APPLICATION NO.	FILING DATE	FIRST NAMED INVENTOR	ATTORNEY DOCKET NO.	CONFIRMATION NO.
10/749,155	12/30/2003	Alan Dry	04224 (3883.00032)	7836
35374	7590 06/07/2005	EXAMINER		INER
	RPORATION, BLISS M	ENGLE, PATI	ENGLE, PATRICIA LYNN	
2075 WEST SUITE 600	2075 WEST BIG BEAVER ROAD SLITE 600		ART UNIT	PAPER NUMBER
TROY, MI	48084		3612	
			DATE MAILED: 06/07/200	5

DETAILED ACTION

Claim Rejections - 35 USC § 103

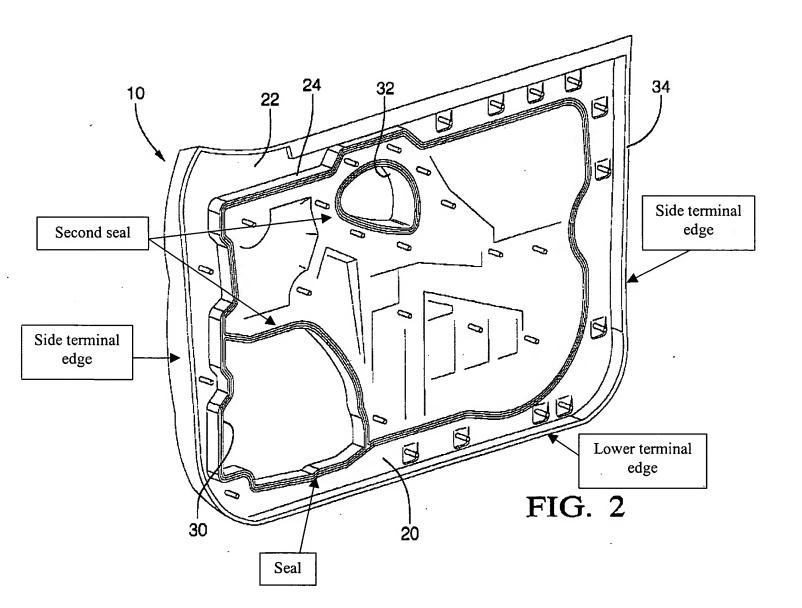
Ota et al. disclose a molded substrate forming a vehicle trim panel which includes an A-side surface in which a portion (B) of the A-side surface (Fig. 2) is visible from the interior of the vehicle.

Regarding claims 7 and 16, Whitehead et al. as modified disclose a modular door trim panel assembly as set forth in claim 5 further including a second seal (142, see illustration above) that is co-molded while said substrate is formed and bonded to said B-side (122) of said substrate, said seal extending substantially around said aperture (30,32 and column 3, lines 25-27) and adapted to prevent the entry of moisture between said B-side of said substrate and the vehicle door through said aperture.
